Re: Minor Project Refinement No. 7 for the TL 6975 San Marcos to Escondido Project.

ATTACHMENT A
MPR-7 Form

TL6975 San Marcos to Escondido 69 kV Project CPUC Minor Project Refinement Form

ATTACHMENT B
MPR-7 Figure

LEGEND

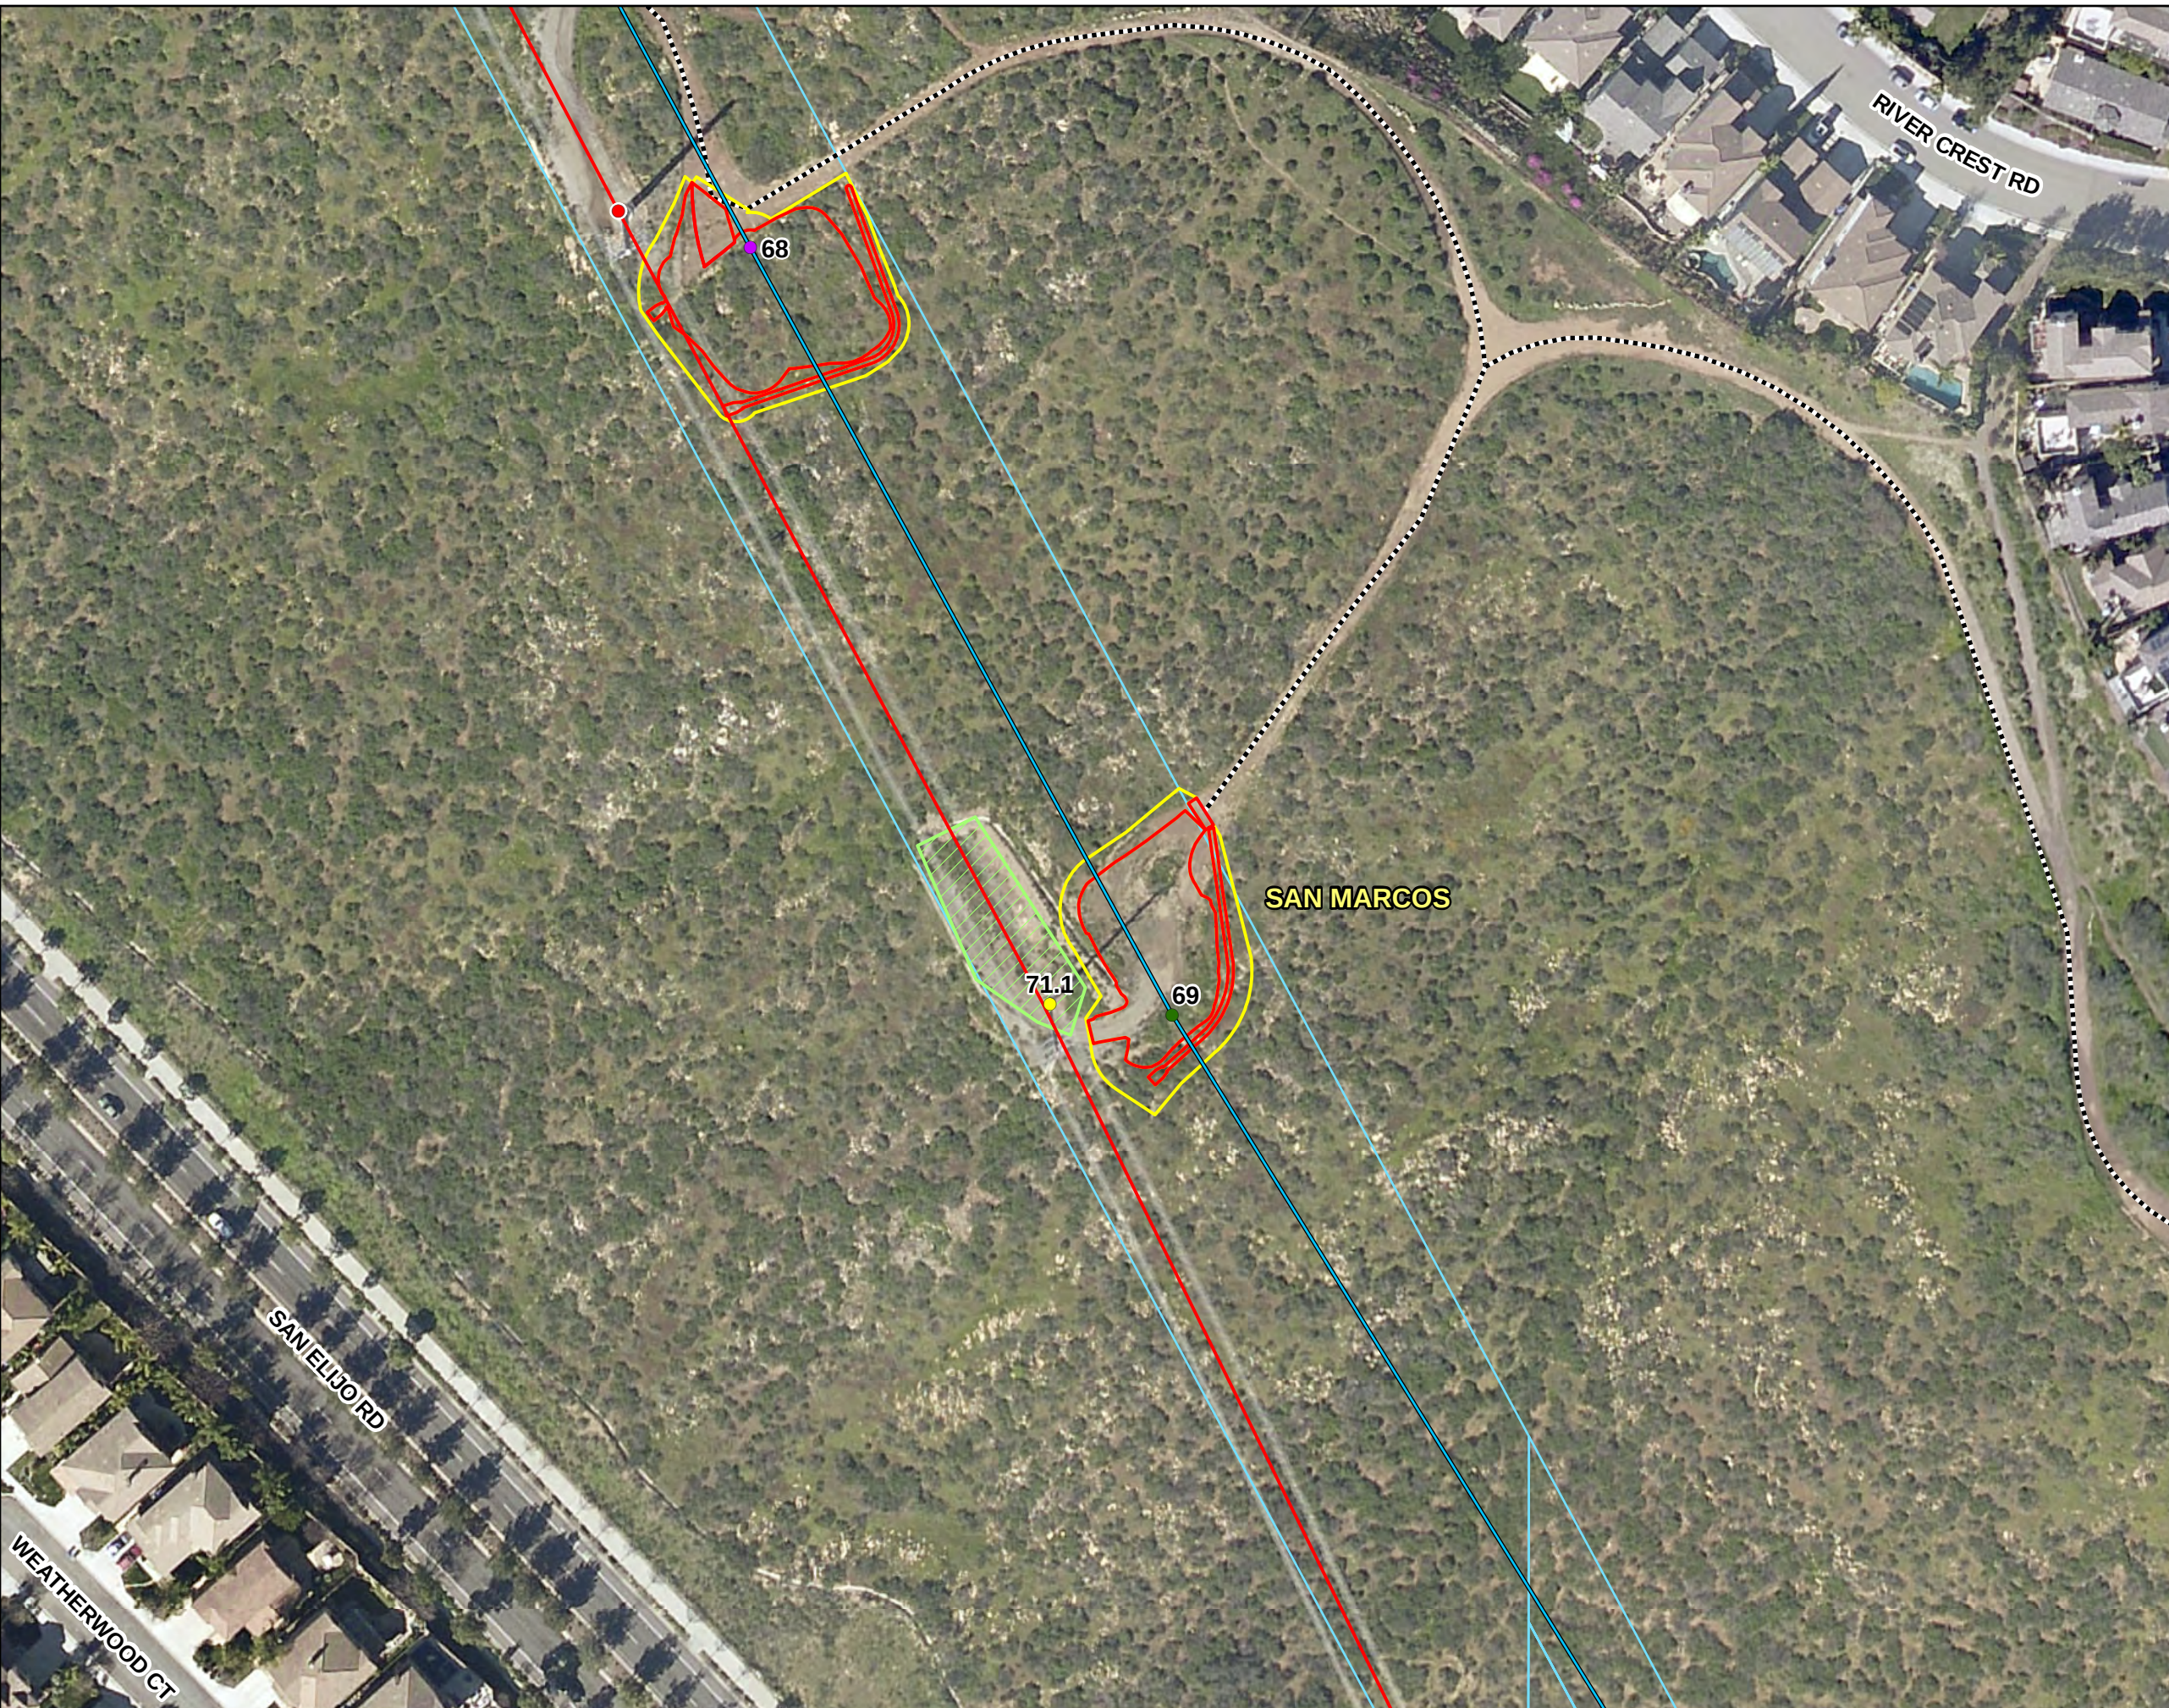
San Diego Gas and Electric (SDG&E) is requesting approval of MPR-7 for five additional temporary work areas (WA) at Locations 57, 62, 63, 64 and 69 to facilitate pole installation activities in Segment 2 of the TL6975 San Marcos to Escondido Project (Project). The additional work areas will be used for temporary staging of materials and equipment associated with the

Following the field constructability review, the construction contractor identified the need to utilize additional space for pier foundation pole installation activities at Locations 57, 62, 63, 64 and 69. In an effort to maximize available space to safely and efficiently perform the pier foundation pole installations while minimizing additional impacts resulting from the Project, MPR-7 is proposing the use of existing maintenance pads and previously disturbed areas to support this work (see **Attachment C, MPR-7 Site Photographs**). The MPR-7 additional work areas would be utilized for temporary staging of materials and equipment such as drill support equipment, water trucks for dust control, rebar cages, etc. In addition, the MPR-7 work areas can be used for safely maneuvering vehicles during pier foundation pole installation activities, such as turn-around areas for cement trucks.
